## DDS2208.1 – 1 Park Hill Drive STATEMENT

| PROPOSAL          | Proposal to amend boundary treatment to 1 Park Hill Drive |

Proposed Site Plan to include low boundary wall around the radius.

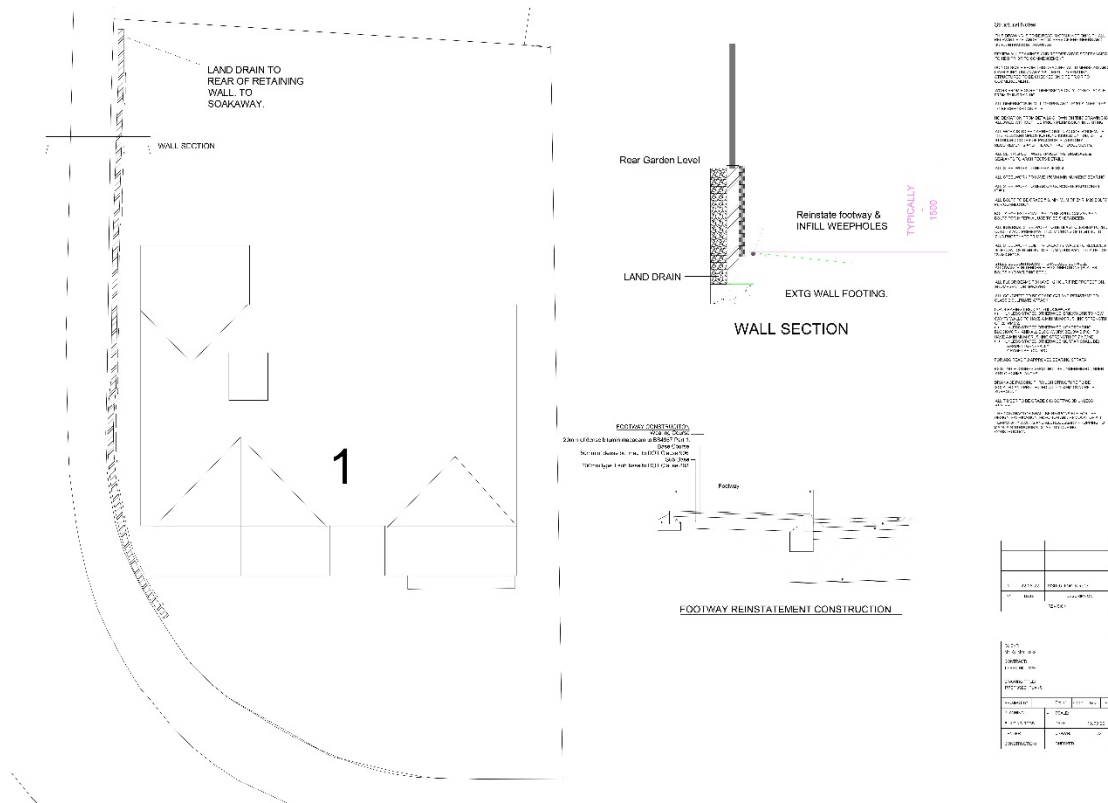
- The proposal results in the reduction in forward visibility at the bend on Park Hill Drive to sub-standard levels, which would be detrimental to highway safety.*

- The proposal results in the reduction in visibility at the junction of the access to the property and Park Hill Drive to sub-standard levels, which would be detrimental to highway safety.*

The proposal has been plotted to show the extent of the removal of the fence. See images below. This would be in line with the corner of the house, as well as the visibility line plotted see visibility splay Site plan.

Feather edge fence lowered to 1m with columns dispersed at 4m in between

Feather Edge Fencing Shown in Red  
Removed including pillar. See visibility splay  
plotted on Proposed Site Plan.
